Addendum No.3
RFP # 2/2019/special supplies

**Design, Implementation, and Operation
of an Intelligent Transportation System
(ITS) for Public Transportation in Jordan**

**A Multitenant, Standards-Based, Account-Based, and
Closed Payment System**

December 17, 2019

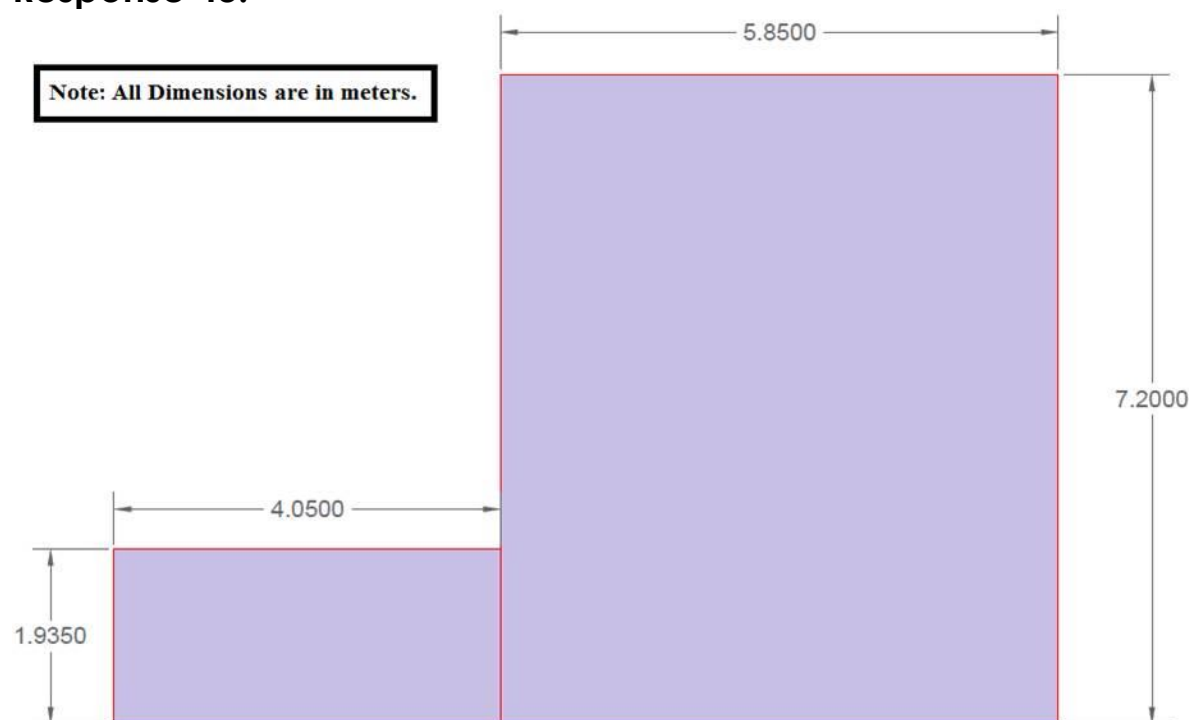
Inquiry 43: Need layout of control room and number of Control center operators

Response 43:

The control room should accommodate Bidders staff in addition to (4) employees from LTRC
